The Corporation of the TOWN OF MILTON

Report No: PD-016-2014

Subject: Technical Report – Proposed plan of subdivision and amendment to the Zoning By-law (the “**Applications**”) by Milton Meadows Properties Ltd. (“**Milton Meadows**”) to lands legally described as Part of Lot 4 and 5, Concession 1, Esquesing, Town of Milton, (the “**Lands**”) to permit development of a residential plan of subdivision (24T-07002/M and Z-02/07).

Figure 2 - Plan of Subdivision
Report PD-016-2014

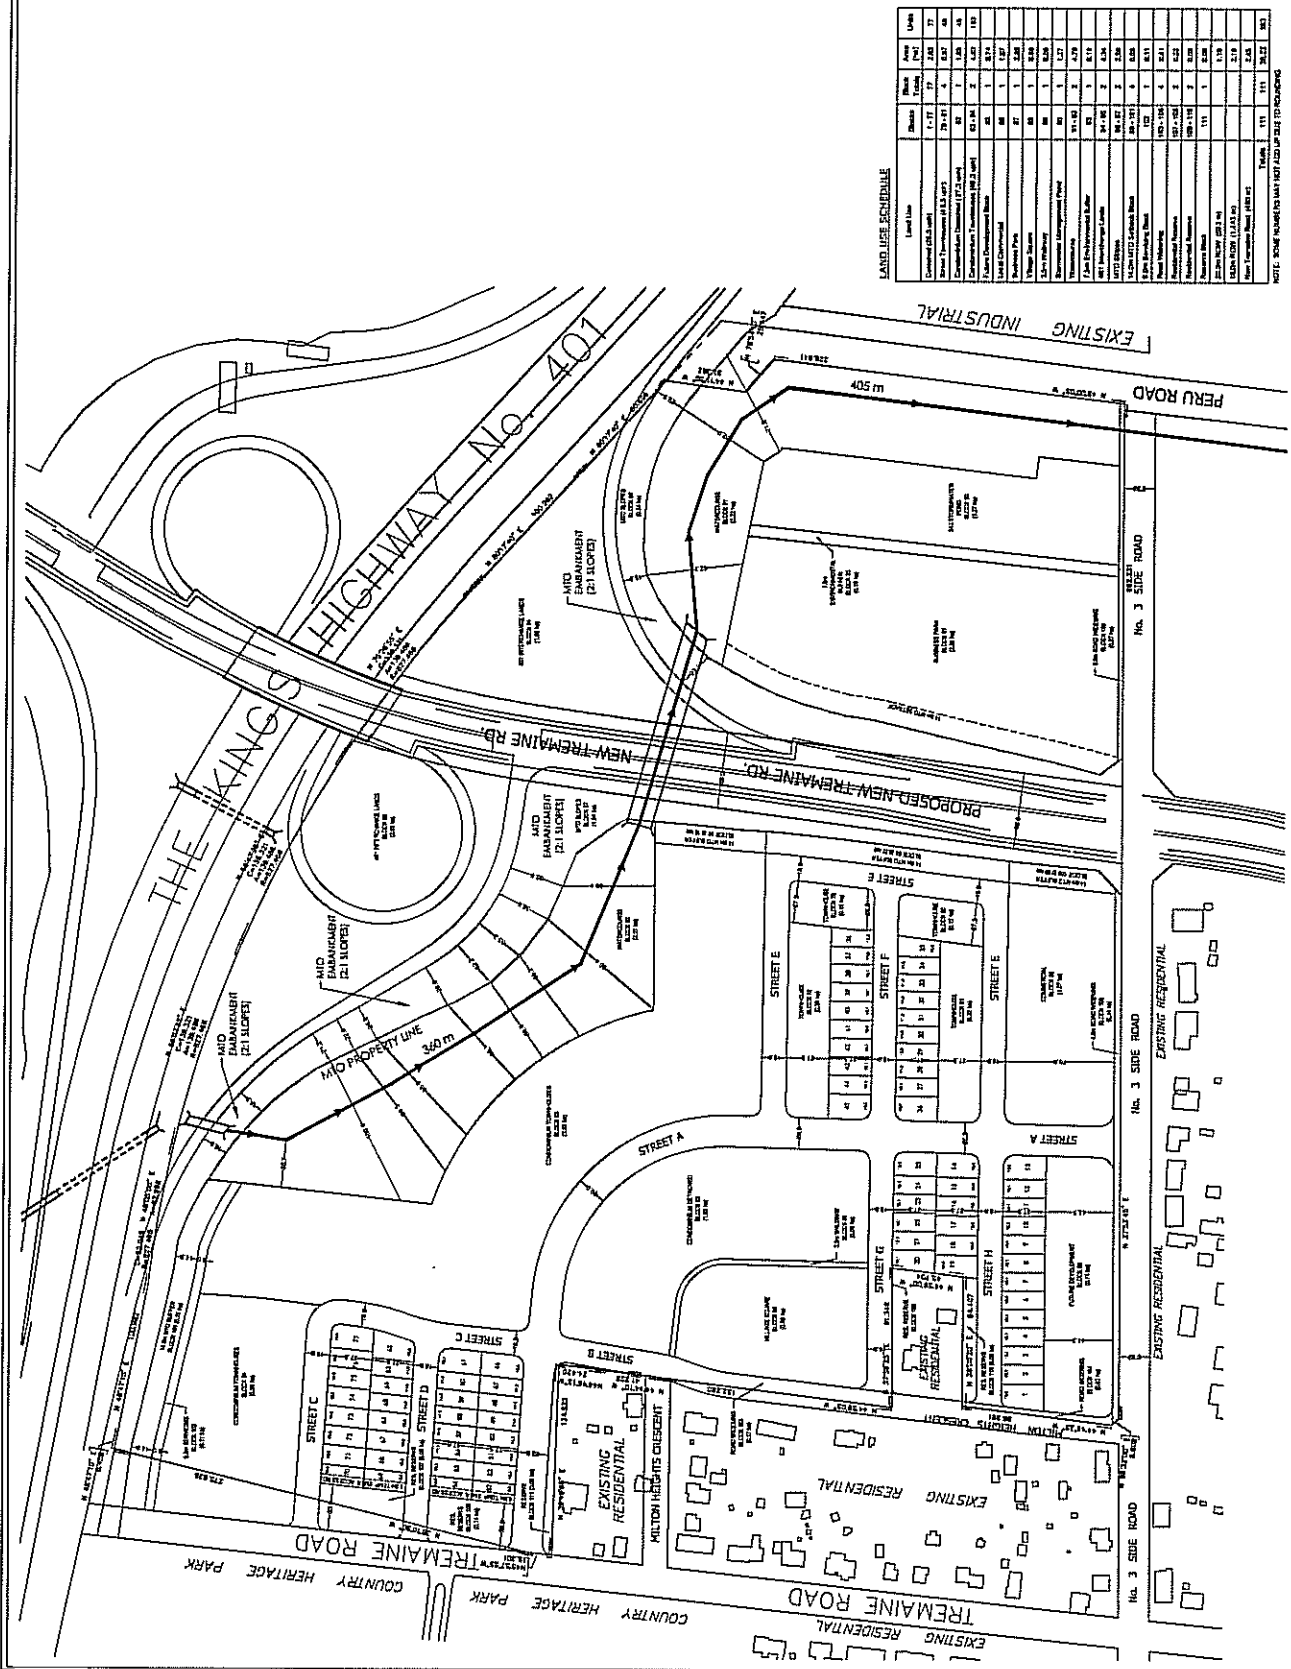
In addition to the foregoing revisions, staff also requires certain other revisions to the draft plan of subdivision in order to achieve conformity with the Town's Official Plan. Such conformity is prerequisite to subdivision approval and good subdivision design. Specifically, staff requires the following revisions to the plan:

- Identify the Residential Reserve Block 109 as a Reserve Block to be conveyed to the Town with the road right-of-way for Street G;
- Delete the Servicing Block 102 and provide a servicing easement over Blocks 83 and 84, generally abutting the walkway block of the proposed condominium, as shown on the concept plan for the condominium townhouse block;
- Provide an additional block between the business park and the environmental buffer block to accommodate an increase in the width of the NW-2-G1 corridor to the satisfaction of the Ministry of Natural Resources, Conservation Halton and the Town;

The plan shows a narrow residential reserve block (Block 109) abutting the existing residential property and Street G. This residential reserve block would restrict access to Street G and the services installed in the right-of-way, should the abutting landowner wish to redevelop his residential property in the future. Staff does not support private ownership of residential reserve blocks. The Town has adopted a Reasonable Efforts Policy to deal with these types of cost recovery issues. Staff requires that this parcel be conveyed to the Town free and clear of encumbrances and has proposed a draft conditions to this effect.

Figure 3 - Proposed Phasing Report PD-016-2014

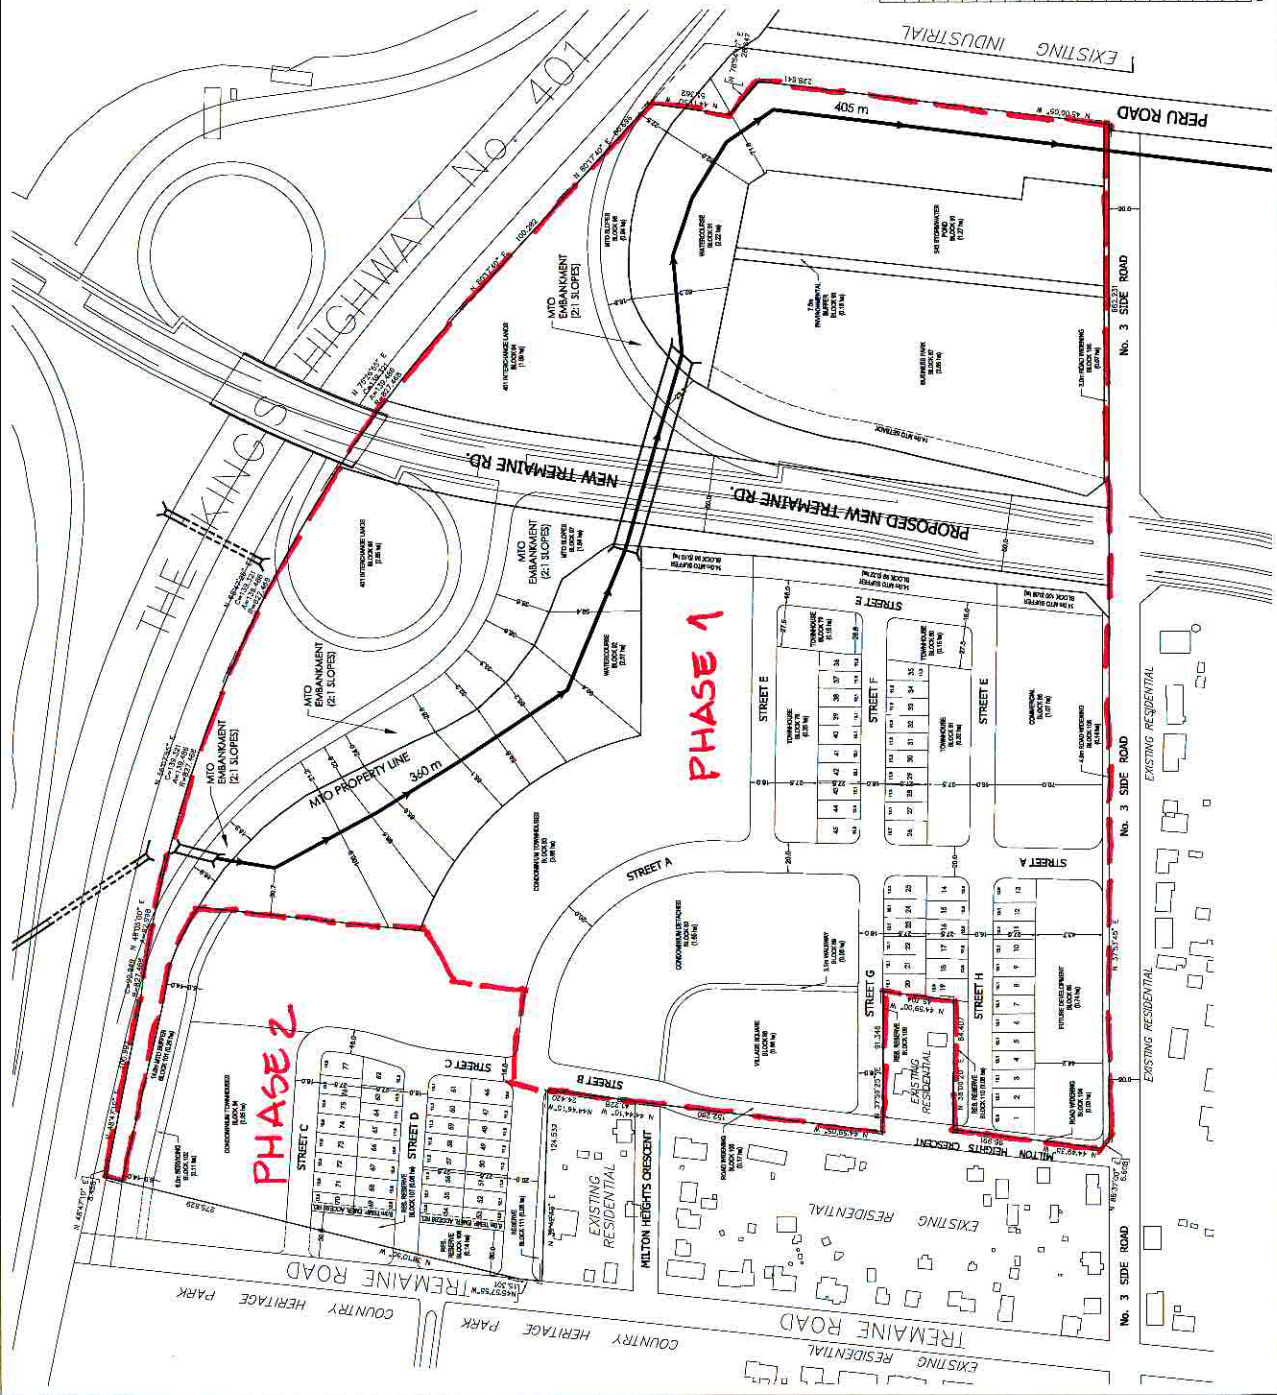
1 of the plan of subdivision, as shown on Figure 3. This is a significant portion, but not all, of the plan. While most of the outstanding technical issues are close to being resolved, servicing allocation has not been secured for that portion of the Lands outside of Phase 1. Halton Region has confirmed that the 2012 Allocation Program is fully subscribed and additional servicing allocation is not available. It is a requirement of Halton Region that servicing allocation is secured prior to the granting of draft plan approval. As such, Halton Region will oppose the granting of draft approval at the upcoming hearing for lands outside of Phase 1, but has no objection to the zoning of the Lands in their entirety. The Town, as the delegated approval authority for plans of subdivision will support the position of the Region at the OMB hearing. Milton Meadows will be seeking draft approval for the entire Lands.

Halton Region staff has confirmed that 200 SDE of servicing allocation has been secured for the Lands and has provided draft plan conditions for Phase 1 of the plan. The Region, with the Town in support, but will be opposing draft approval for Phase 2, for which servicing allocation has not yet been secured, at the upcoming hearing.
